SUNDY NOTICES AND REPORTS ON WELLS
Do not use this form for proposals to drill or to re-enter an abandoned well. Use form 3160-3 (APD) for such proposals.

Pintail 23 Federal Com No. 1

On 06-03-08, Cimarex submitted a 3160-5 with plans to revise its Re-entry plans for the Pintail 23 Fed Com No. 1 to a Horizontal Cisco Recompletion.

**PECOS DISTRICT
CONDITIONS OF APPROVAL**

WELL LOCATION AND ACREAGE DEDICATION PLAT

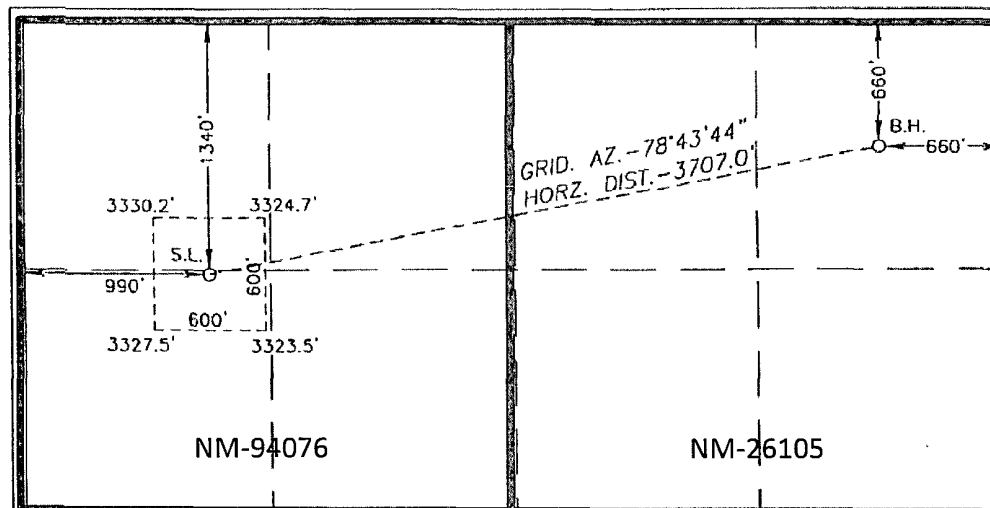
Cimarex would like to change its proposed BHL for this well as shown on the attached plats. The preliminary directional survey has also been revised and is attached. All that has changed in the proposed drilling plan is the TD, shown below:

UL or lot No.	Section	Township	Range	Lot Idn	Feet from the	North/South line	Feet from the	East/West line	County
A	23	25-S	26-E		660	NORTH	660	EAST	EDDY
Dedicated Acres 320	Joint or Infill	Consolidation Code P	Order No.

Well Profile Data

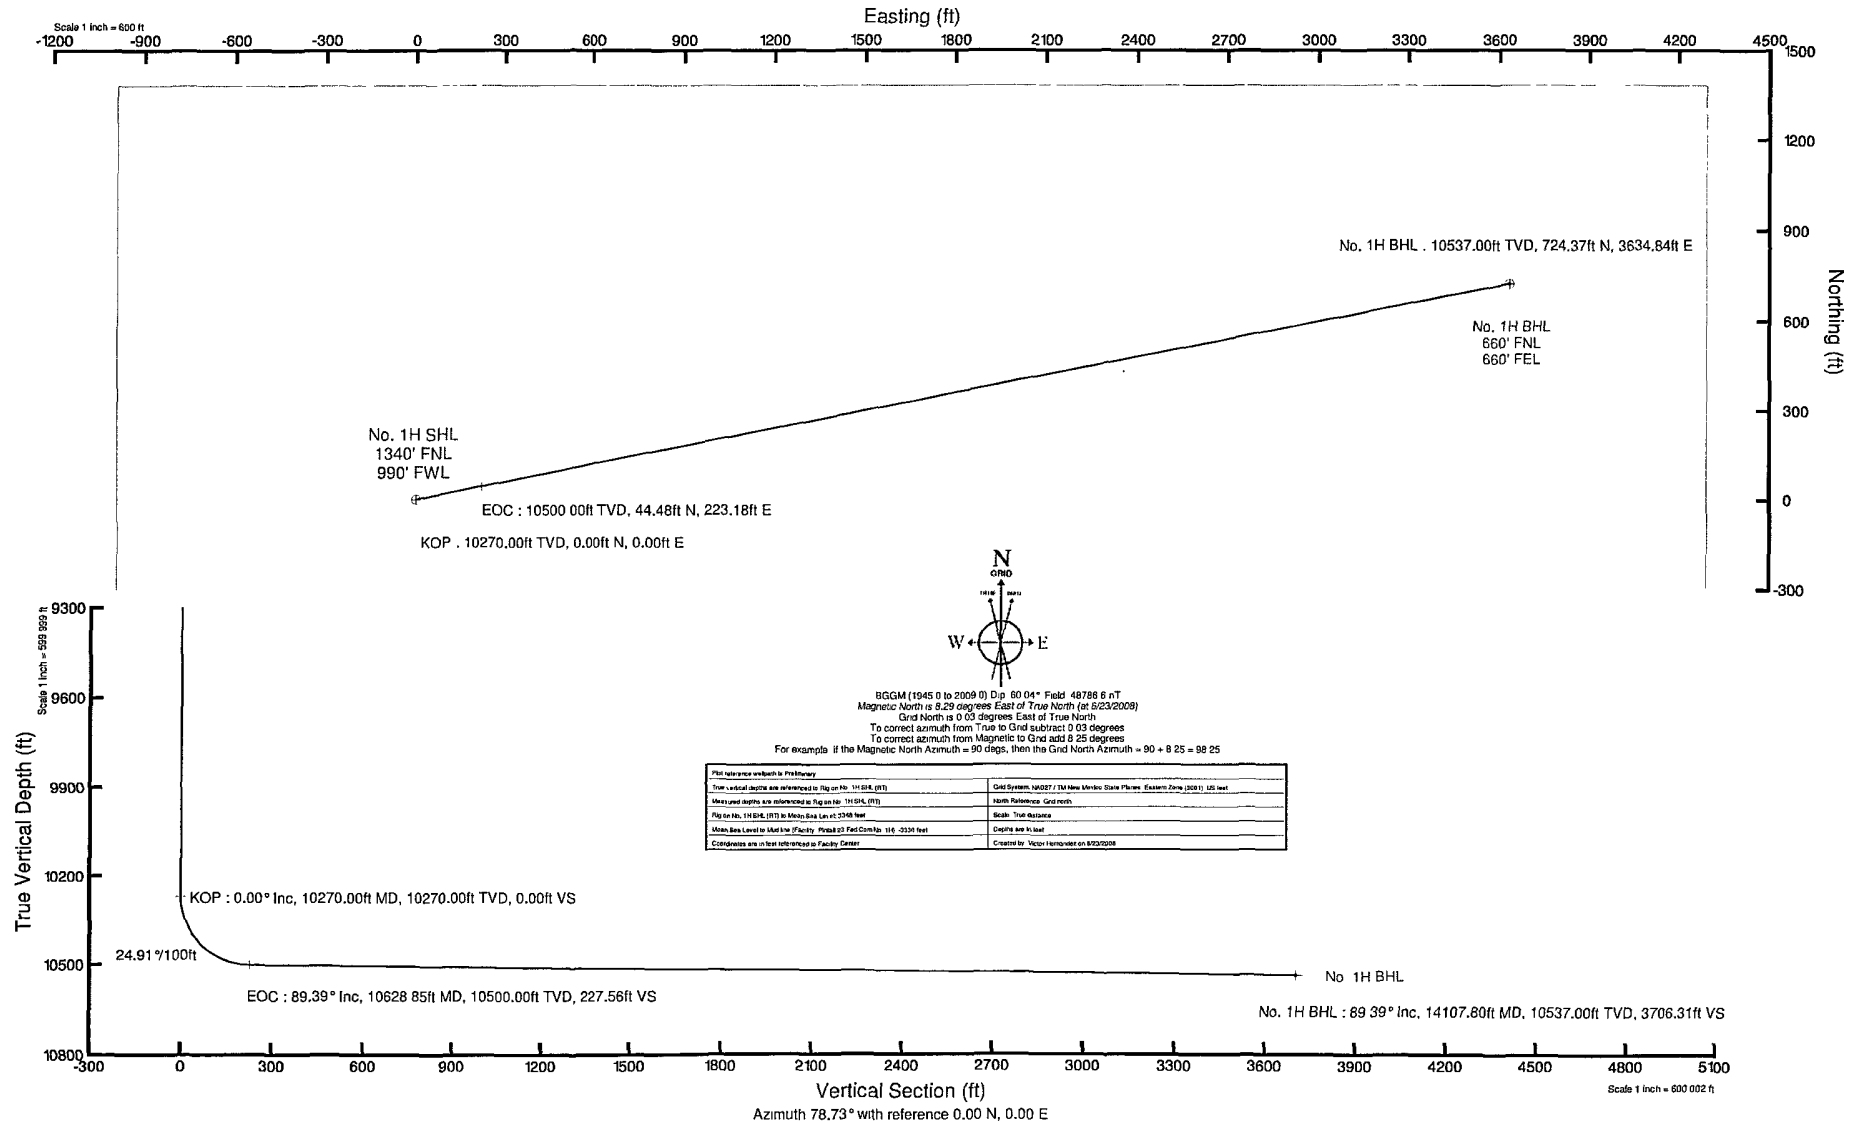
Please see attached revised plat and revised preliminary directional survey.
